FOR PERCOLATION TESTING AND SITE EVALUATION

RE: Percolation test results for 6905 Brooks Road, A533989

**PERC APPLICATION PLAT
PASTINE PROPERTY
LOT 2
PLAT REFERENCE: #6289**

**PERC CERTIFICATION PLAT
PASTINE PROPERTY
LOT 2
PLAT REFERENCE: #6289**

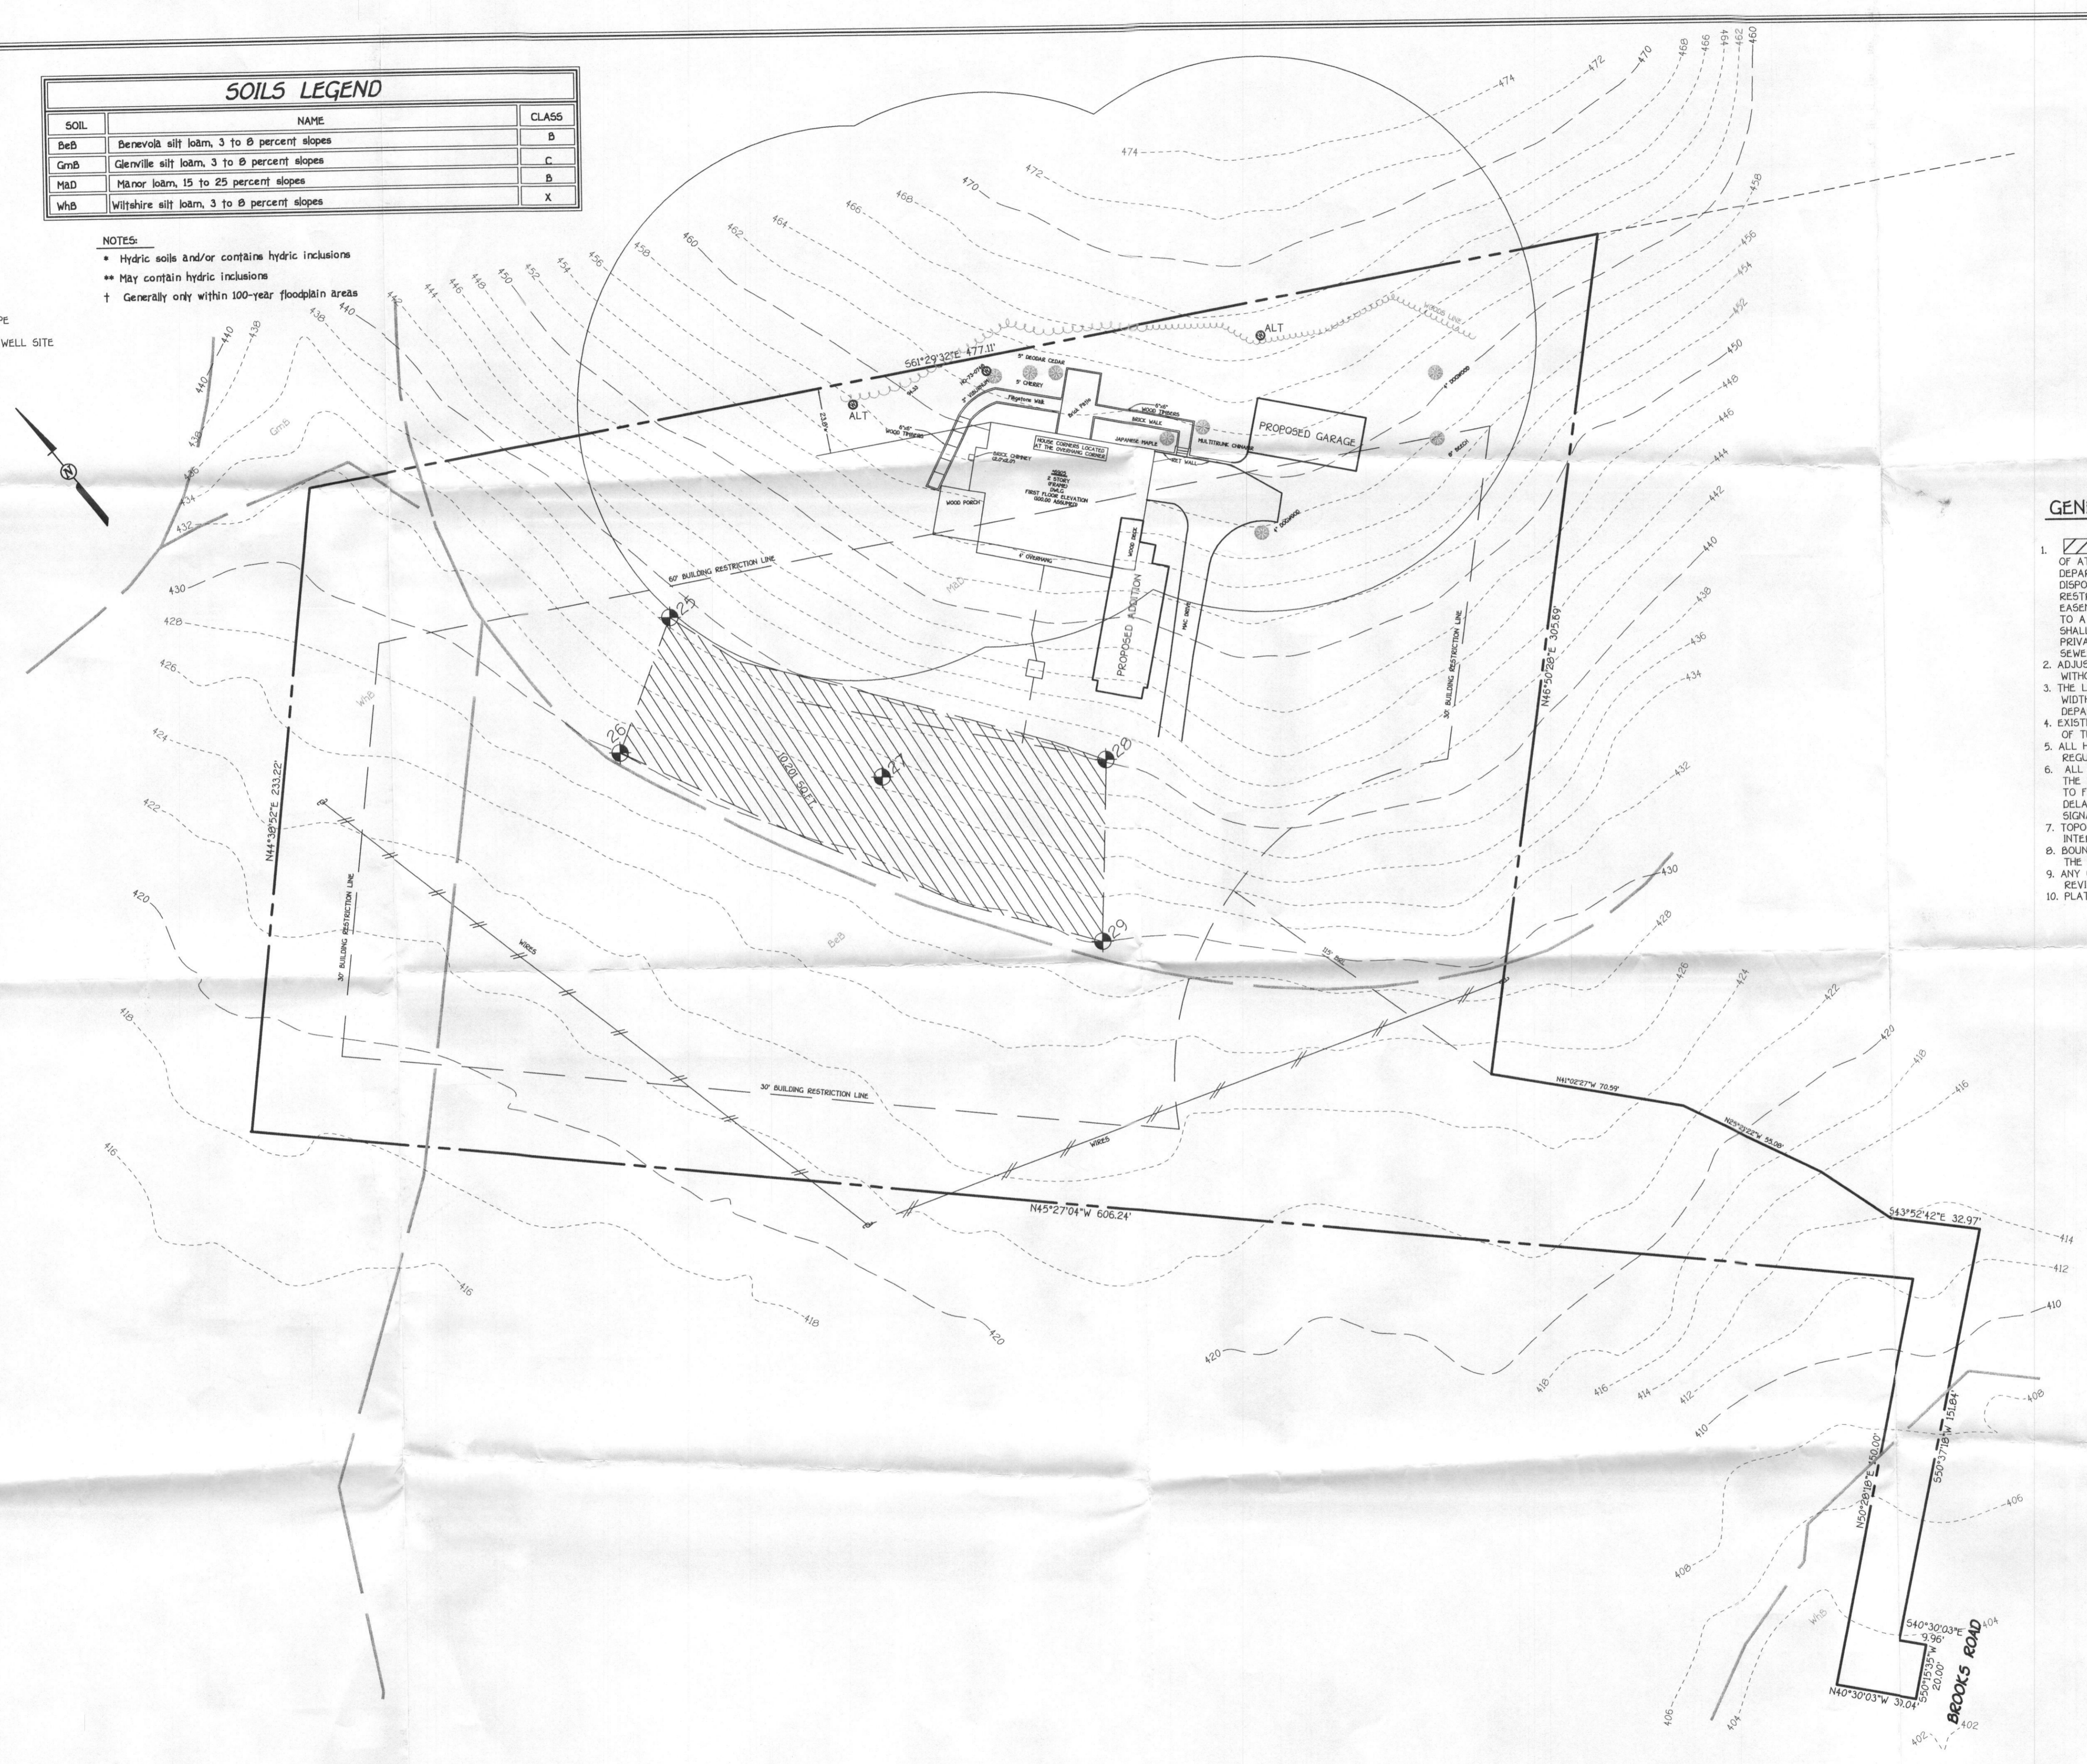
Test holes were dug near staked locations 26 through 29. Test #25 was moved about 60 feet southeast of the stake due to the occurrence of fill and disturbed soils in the northeast corner of the proposed septic reserve. After these 5 tests and observations were completed, 2 additional test locations (30 and 31) were added. Summarizing results of unsatisfactory tests or observations: location 25 has a relatively shallow depth to indurate rock and a slow percolation rate. At location 31, the soil has fine textures and as the soil is relatively dense, a slow to very slow percolation rate occurs. Neither a free water table nor perched water was observed in any of the soil profiles.

Areas that may be included in a septic easement are represented by test locations having satisfactory soil conditions, which are locations 26, 27, 28, 29 and 30. Percolation rates in the area appropriate for inclusion in a septic reserve range from moderate (26, 27 and 28) to moderately slow (29 and 30).

The existing septic tank was observed, however the existing trench was not encountered and therefore its location remains unknown. Health Department records indicate that the septic tank has a capacity of 1500 gallons. The septic tank outlet invert is about 5.3 feet below ground elevation. If the planned addition increases the enclosed living area of the residence to greater

The existing trench is described as having 6 feet of gravel below the pipe, with the trench bottom at 8 feet depth. As the trench location is described, it lies in the area generally between locations 28 and 25, though it may be a little further downhill. The soil depth to indurate rock at locations 28 and 25 is only 8 feet and 9 feet respectively. At location 27 the depth to indurate rock is only 11 feet. The depth to indurate rock at the existing trench must be at least 12 feet for it to be certified as meeting code requirements. I believe that the soil materials do not extend to 12 feet and therefore the trench will need to be abandoned for the Health Department to approve a building permit application affecting the existing house. As a result a new drainfield will be required.

The existing well was not observed during the percolation testing. An inspection of the well will be conducted by an Environmental Sanitarian prior to signature approval of the Percolation Certification Plan. The plan will show the existing well and two replacement well locations (or a 1500 square-foot well reserve) will also be delineated.

than 3500 square feet, the required septic tank capacity will be 2000 gallons. A second septic tank may be installed to supplement the capacity of the existing septic tank though all regulated setback distances must be observed. A manhole (top-of-tank to grade) will be installed on each tank.
